UNITED STATES PATENT AND TRADEMARK OFFICE

APPLICATION NO.	FILING DATE	FIRST NAMED INVENTOR	ATTORNEY DOCKET NO.	CONFIRMATION NO.
10/026,477	12/27/2001	Hong Suk Yoo	8733.561.00	7762

Office Action Summary

DETAILED ACTION

FIG.8D

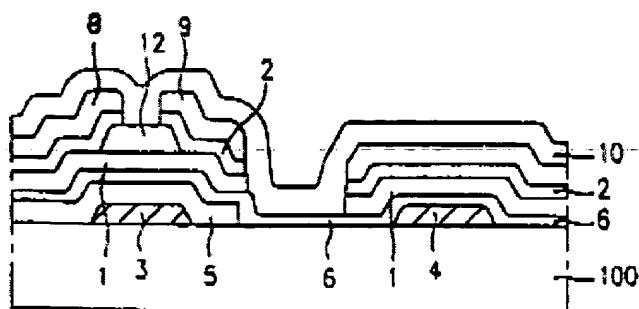
As to claim 15, Moon discloses in the 5th embodiment (col. 6, lines 8-63 and Figures 8A-8D) a liquid crystal display (LCD) device comprising:
a first substrate , 100; a second substrate;
a liquid crystal layer formed between the first and second substrates;
a storage capacitor, (combination of 4, 6, 1, 2, and unlabeled 9; col. 6, lines 10-30),
formed in a first region of the first substrate;
a thin film transistor formed in a second region of the first substrate.

a pixel electrode (not shown, inherent to comprise functional device) electrically connected to the conductive layer (unlabeled layer between layers 2 and 10 above 4 in Figure 8D) and a drain electrode, 9, on the thin film transistor, wherein the length of the conductive layer is shorter than the length of the storage capacitor electrode, 4, per Figure 5.

As to claim 17, Moon discloses in Figure 8D the liquid crystal display device as claimed in claim 15, further comprising a semiconductor layer, 1, formed above the second insulating layer in the second region and used as a channel of the thin film transistor.

As to claim 18, Moon discloses in Figure 8D the liquid crystal display device as claimed in claim 17, further comprising a source electrode, 8, and a drain electrode, 9, opposing each other and formed above the semiconductor layer.

As to claim 19, Moon discloses in Figure 8D the liquid crystal display device as claimed in claim 18, wherein the conductive layer (unlabeled 9 between 2 and 10) is of the same material as the source and drain electrodes and formed on the second insulating layer in the first region.

As to claim 20, Moon discloses in Figure 8D the liquid crystal display device as claimed in claim 18, further comprising an ohmic contact layer, 2, formed at an interface between the source and drain electrodes and the semiconductor layer.

As to claim 21, Moon discloses in Figure 8D the liquid crystal display device as claimed in claim 18, further comprising a passivation layer, 10, having a contact hole and formed on an entire surface including the conductive layer and the source and drain electrodes to expose upper portions of the drain electrode and the conductive layer.

As to claim 22, Moon discloses in Figure 8D the liquid crystal display device as claimed in claim 21, wherein the pixel electrode electrically connects to the drain electrode and the conductive layer through the contact hole (inherent to a functional device and obvious to those having ordinary skill in the art given the other embodiments of Moon).

FIG.5

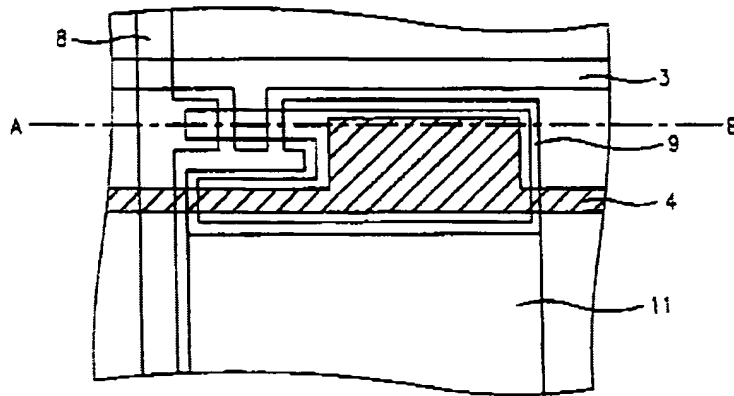
a gate electrode, 3, for the thin film transistor and a storage capacitor electrode, 4, spaced apart from the gate electrode [note it comprises the line running off Figure 5 on both sides], both formed on the first substrate;

Figure 7A

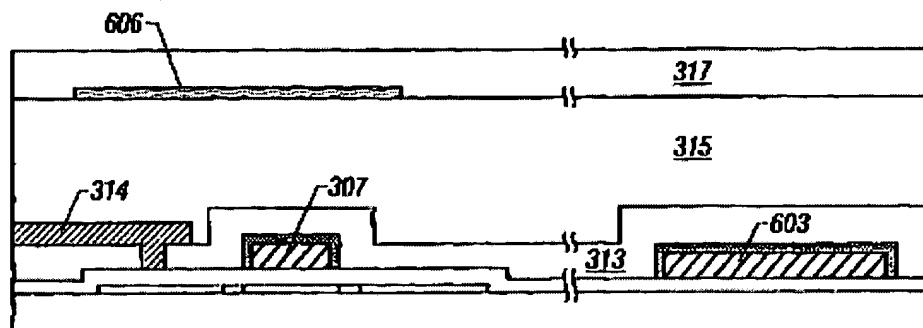
Yamazaki teaches the advantages [col. 10, lines 1-19] of making the conductive layer width shorter [portion of 607 close to electrode 603] than the width of the storage capacitor electrode in order to maximize aperture ratio while still achieving needed capacitance with a thinner insulating layer [removed portions of 317 and 315].

Yamazaki is evidence that workers of ordinary skill in the art would find the reason, suggestion, or motivation to make the conductive layer width shorter [portion of 607 close to electrode 603] than the width of the storage capacitor electrode in order to maximize aperture ratio while still achieving needed capacitance with a thinner insulating layer [removed portions of 317 and 315].
